Local Government Act Approval – S68A2022/0035

Approval for drainage works under S 68 of the Local Government Act 1993 and pursuant to the Environmental Planning and Assessment Act 1979 S 109C (1), 81A (3) and 81 A (4)

PROPOSED RESIDENTIAL DEVELOPMENT
TYPE: ALTERATIONS AND ADDITIONS

ADDRESS: No.9 SURREY AVENUE, COLLAROY
TITLE: LOT 20 (SEC 2)/DP10649
DRAWING SERIES: STORMWATER MANAGEMENT PLAN

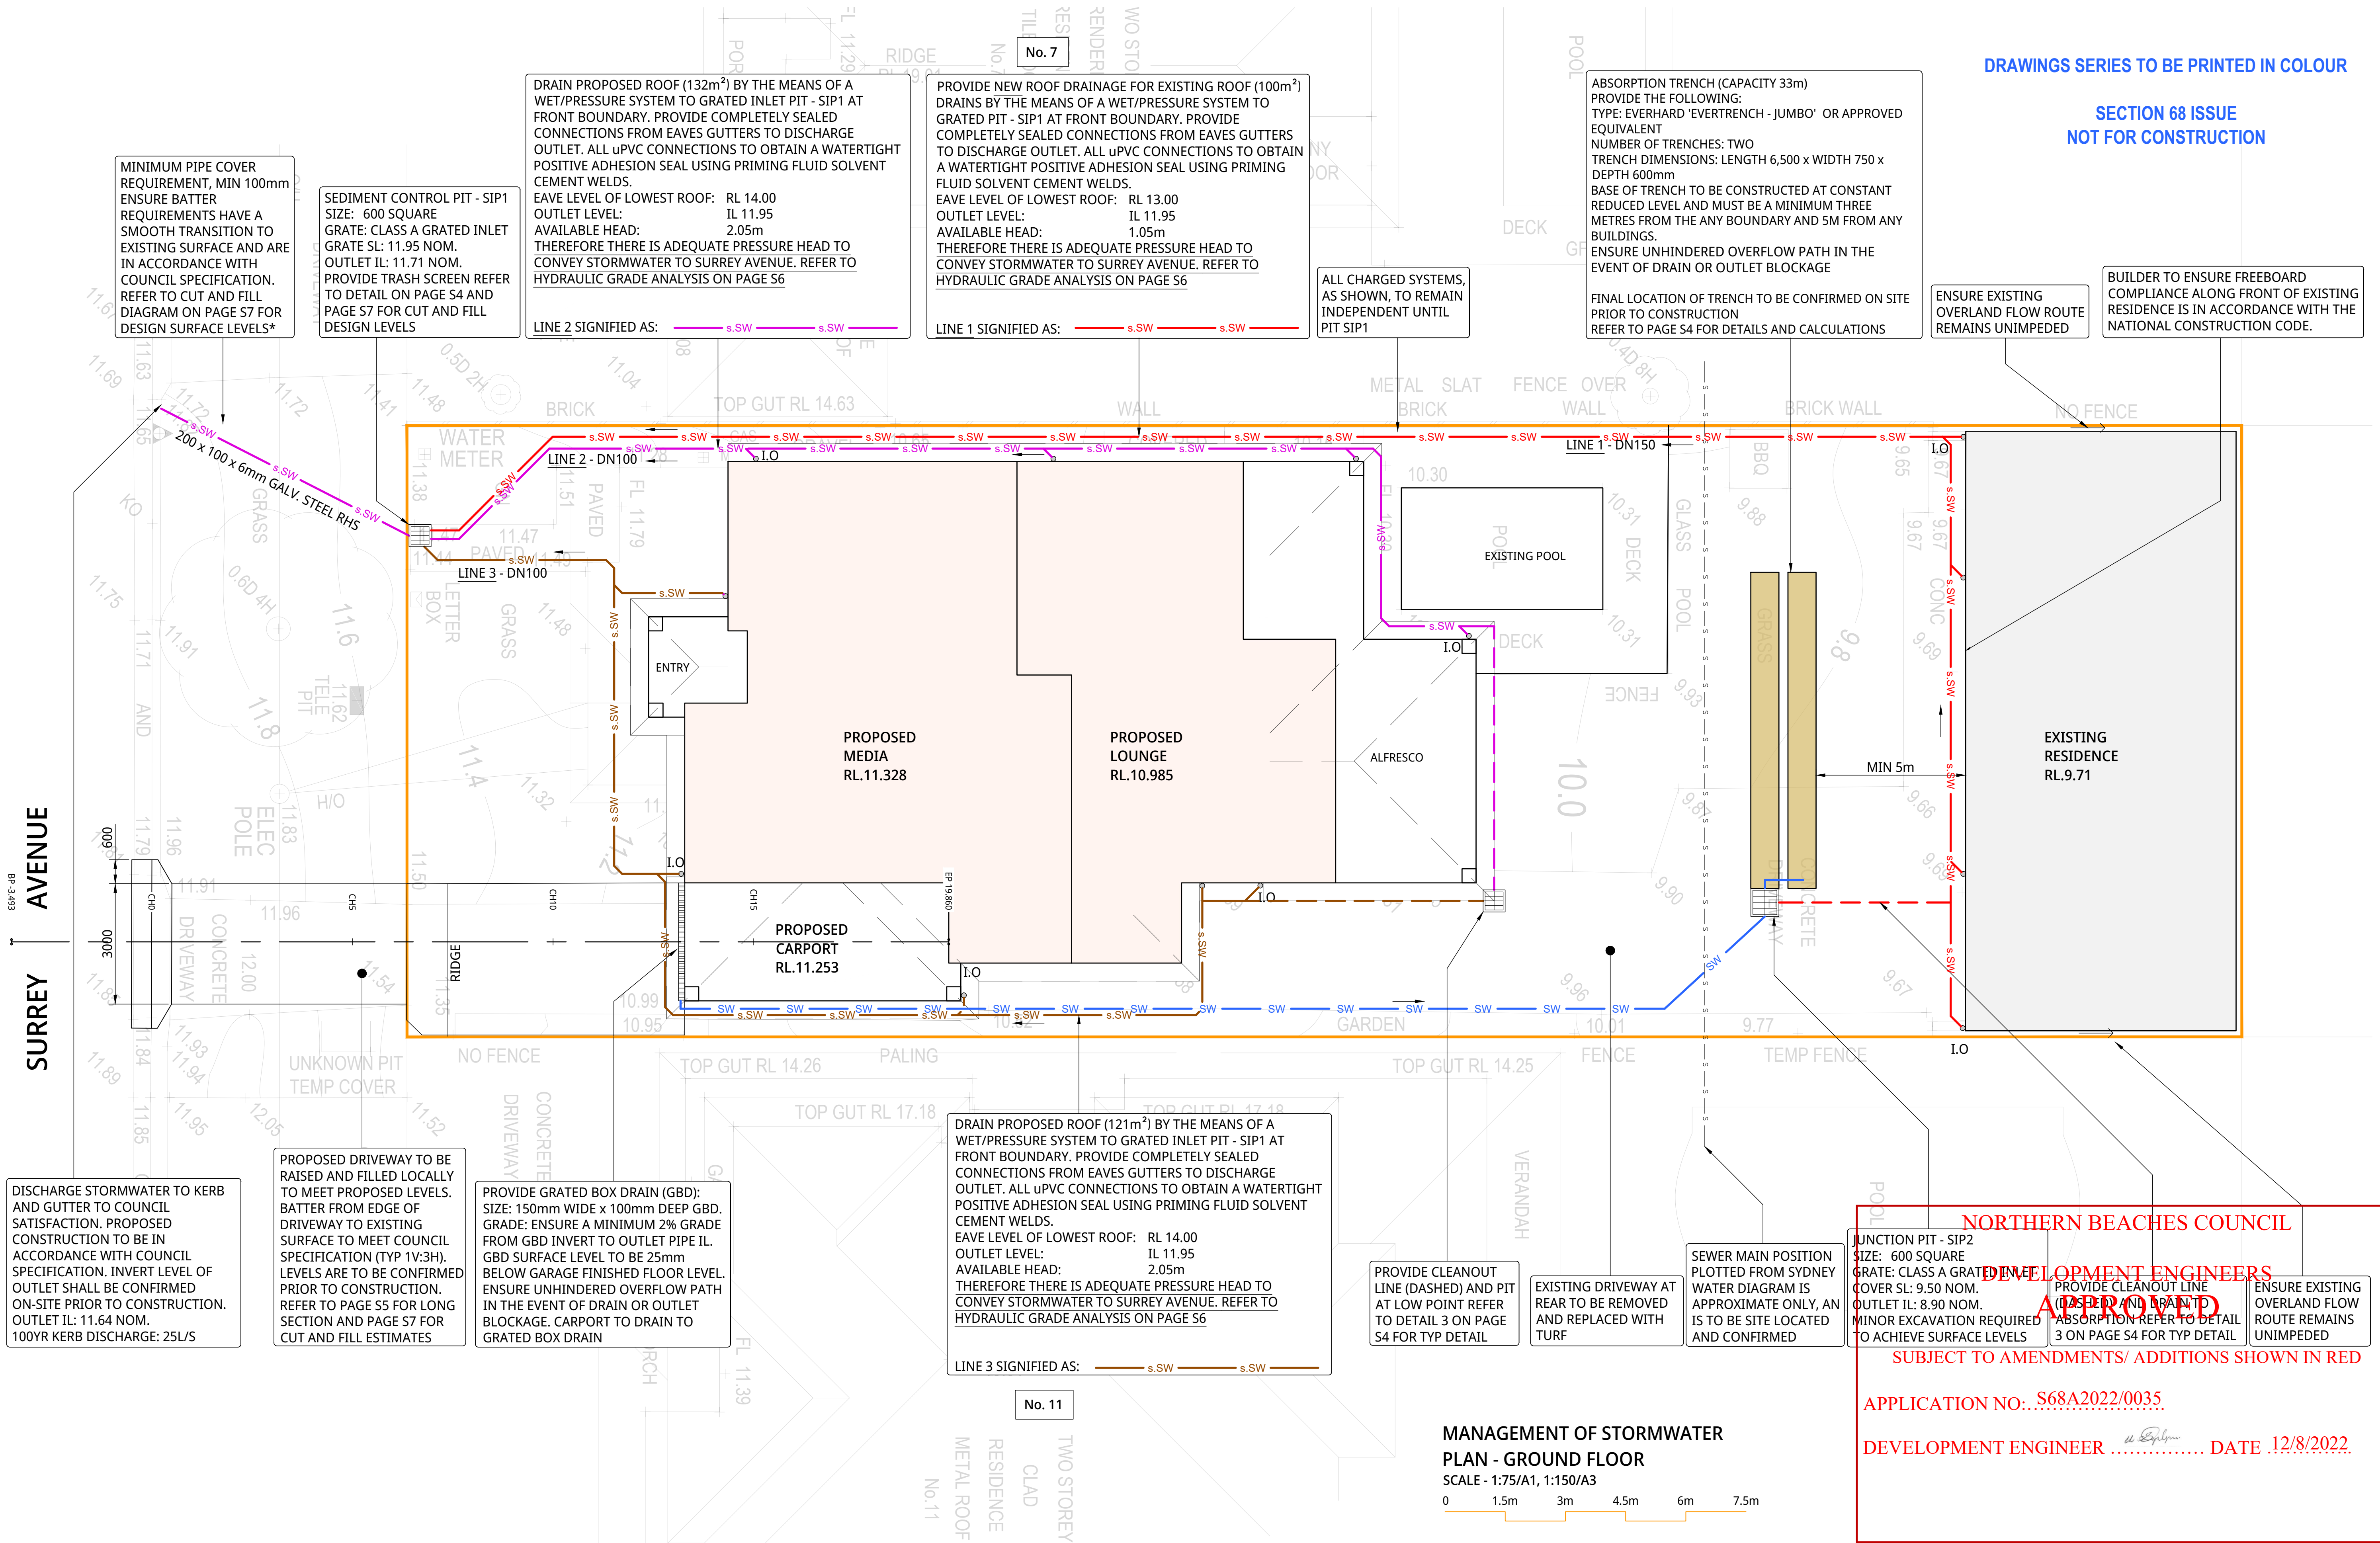
PROVIDE CLEANOUT LINE (DASHED) AND PIT AT LOW POINT REFER TO DETAIL 3 ON PAGE S4 FOR TYP DETAIL

ENSURE EXISTING OVERLAND FLOW ROUTE REMAINS UNIMPEDED
